**Comments for Docket 22-BSTD-01 2025 Energy Code Pre-Rulemaking**

Re: Request for comment and Pre-Rulemaking Title 24 2025, Solar Swimming Pool and Spa Heating, Docket # 22-BSTD-01, **UPDATED August 16, 2023**

# Typical Solar collector plumbing kit available in market

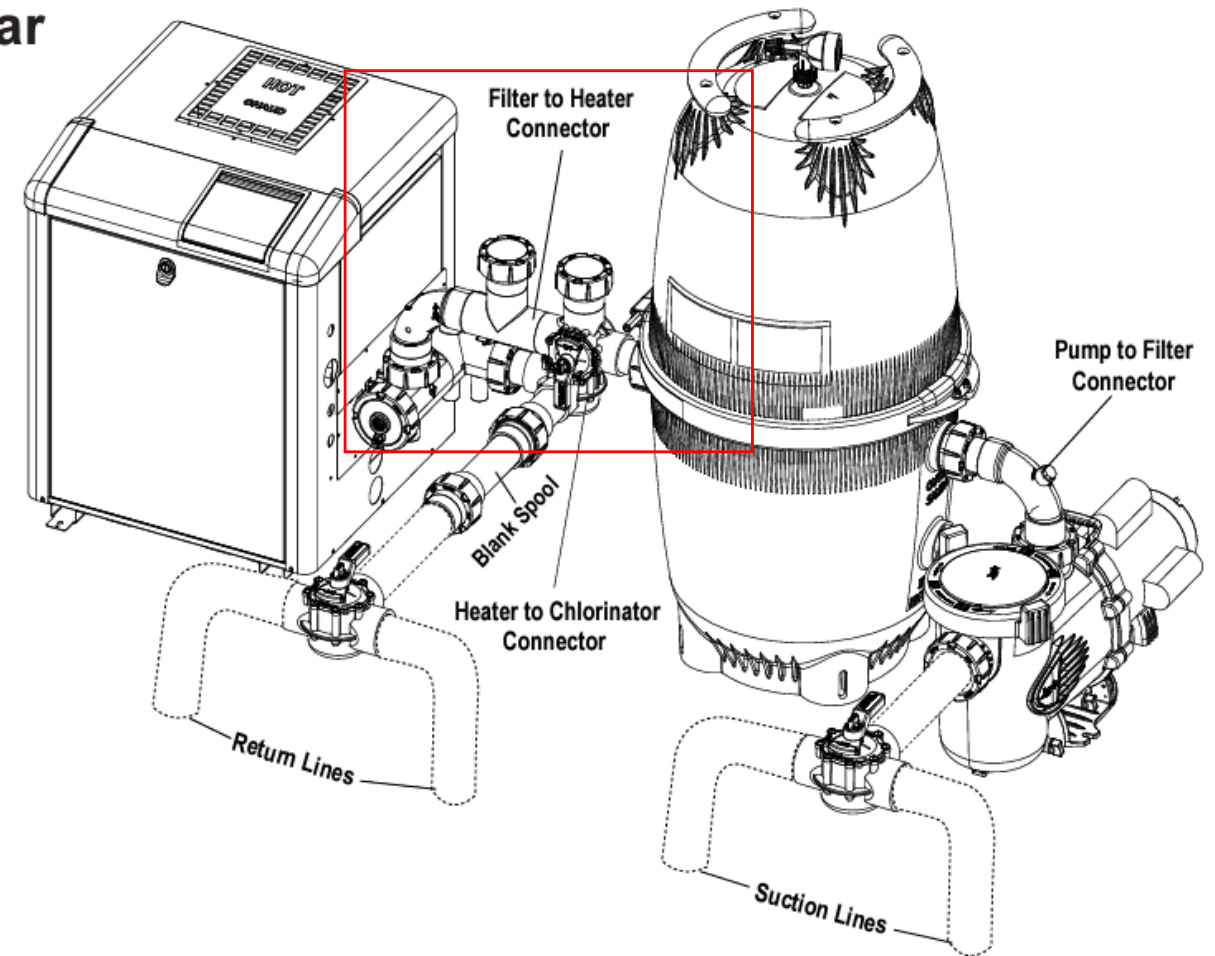
2. **Piping.** At least ~~36~~ 18 inches of pipe shall be installed between the filter and the heater or dedicated suction and return lines, or built-in or built-up connections shall be installed to allow for the future addition of solar heating equipment.

There is often very limited space on a pool pad to set all pool equipment. 36 Inches of piping would be an unnecessarily inordinate amount for solar heating plumbing connections. Attached is a drawing for a standard solar plumbing kit that is available in the marketplace that accommodates 2" and 2.5" plumbing which can easily be installed with the suggested 18 inches of
